Hanford Waste Management Area C WIR Evaluation 10-25-2018 DOE-NRC Teleconference Summary

The following topics regarding NRC's review of the Draft Waste Incidental to Reprocessing (WIR) Evaluation for Closure of Waste Management Area C (WMA C) at the Hanford Site were discussed during an October 25, 2018 teleconference. These topics on Saturated and Unsaturated Flow and Transport were scheduled to be discussed on the 10-11-18 teleconference but were omitted due to time constraints. The following non-sequential numbering is used to be consistent with the topic listing for the 10-11-18 teleconference. This teleconference was open to the public. The call in information for this teleconference was posted on the following DOE Hanford webpage:

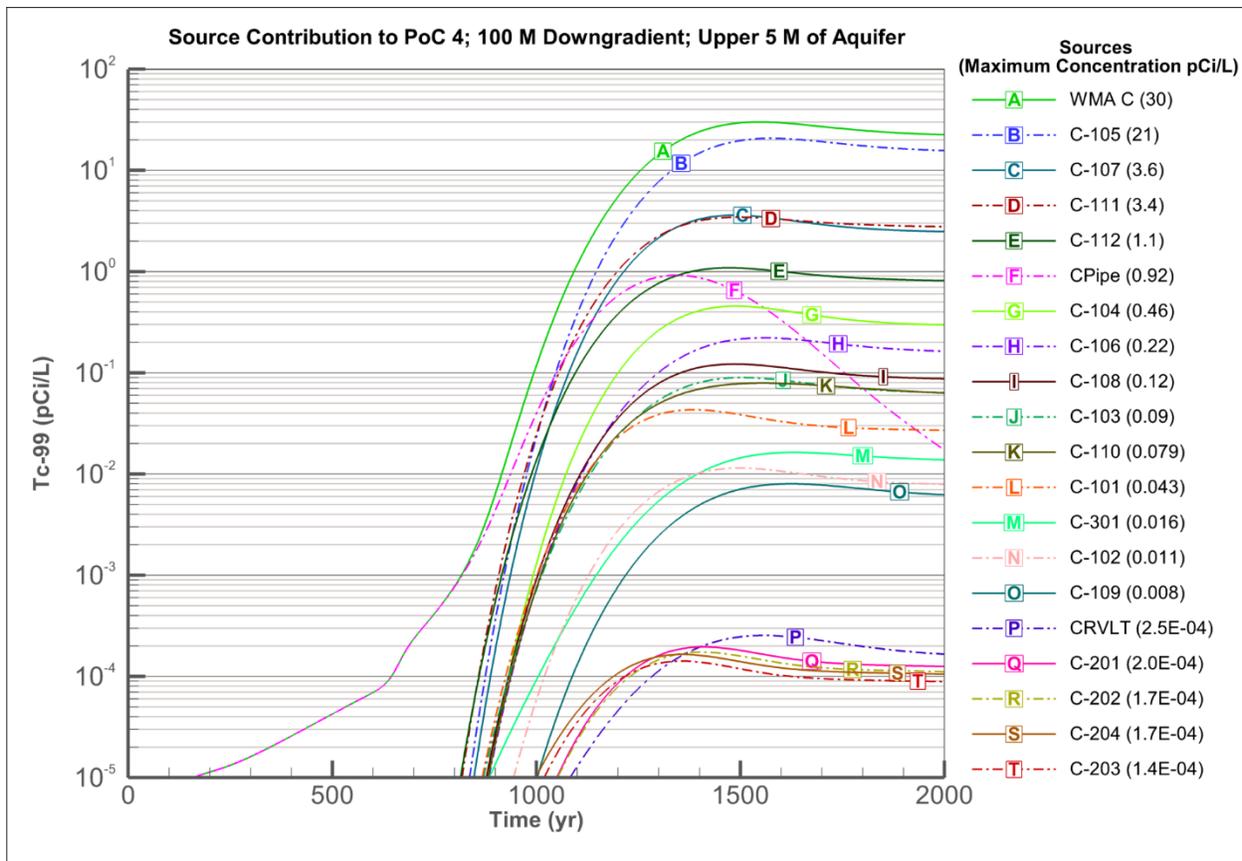
5. DOE provided additional detail regarding PA Figures 7-12, 7-13 and 7-14. DOE stated that the center point of the two cutaways is approximately Tank C-105 and confirmed that the largest contour interval presented in Figure 7-12 is 900,000 pCi/L. DOE additionally stated that there are 270 nodes with concentration greater than 900,000 pCi/L, and that the maximum concentration at any node is 6,055,749 pCi/L.
6. DOE provided the below figure illustrating the area used to represent the pipeline source within the STOMP model.

vzp05 Case Flow Field 1000 years after assumed closure

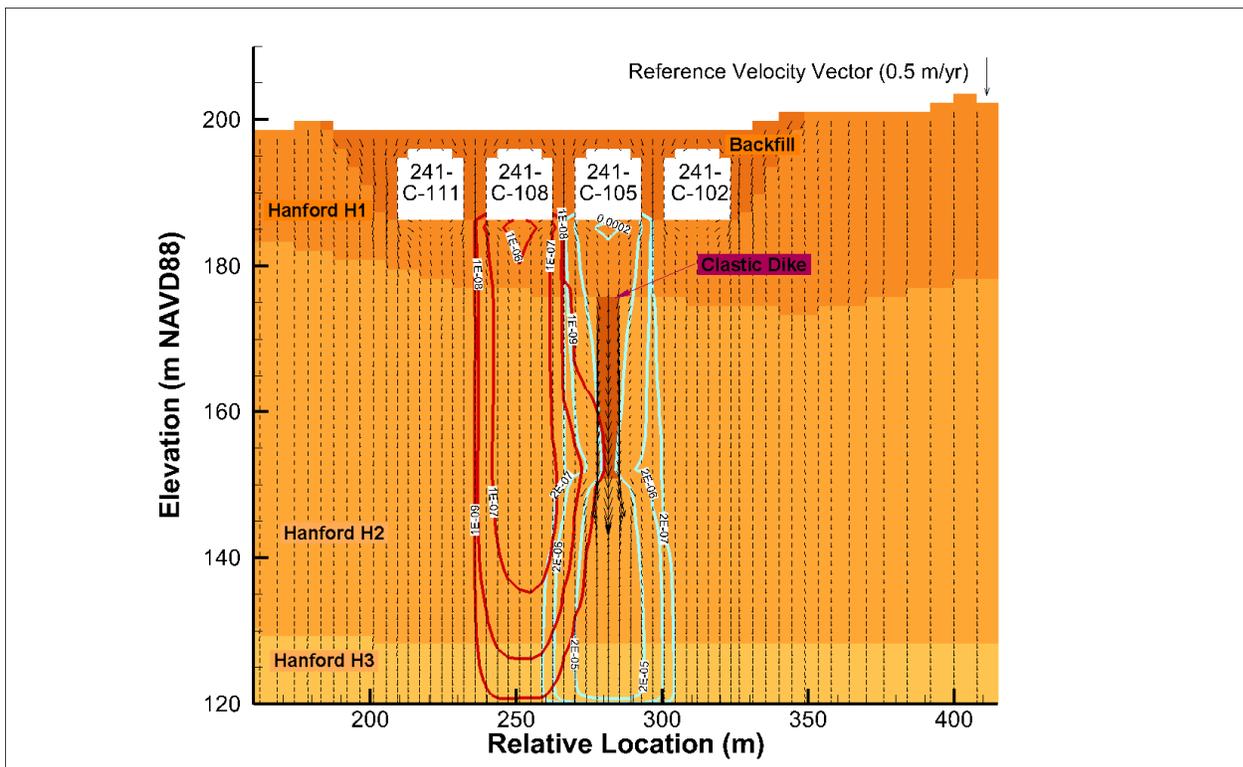
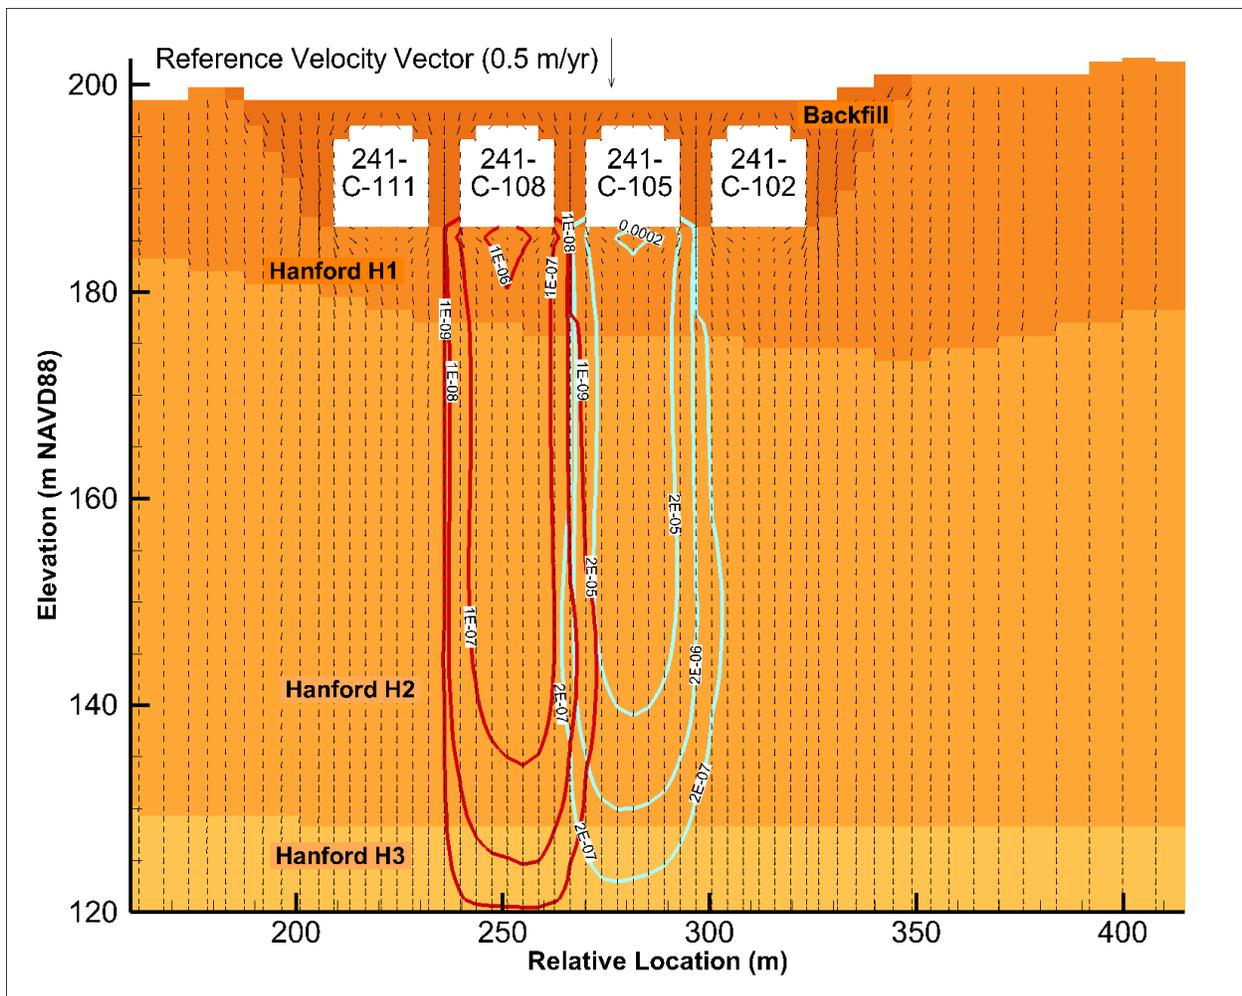
9. DOE provided supplemental information related to sensitivity case vzp05, including a figure that shows the location of the clastic dike modeled and its effect on unsaturated flow and transport. DOE also provided the below hydraulic parameters that were used to represent the clastic dike.

Sample #	Θ (m ³ /m ³) at $K = 1.11 \times 10^{-8}$ cm/s (3.5 mm/yr) (Mualem $m = 1 - 1/n$)	V (cm/s)	V (mm/yr)
1	2.03E-01	5.47E-08	17.3
2A	5.25E-02	2.11E-07	66.7
2B	6.72E-02	1.65E-07	52.0
3A	4.44E-02	2.50E-07	78.8
3B	1.37E-01	8.11E-08	25.6
4A	7.14E-02	1.55E-07	49.0
4B	4.76E-02	2.33E-07	73.6
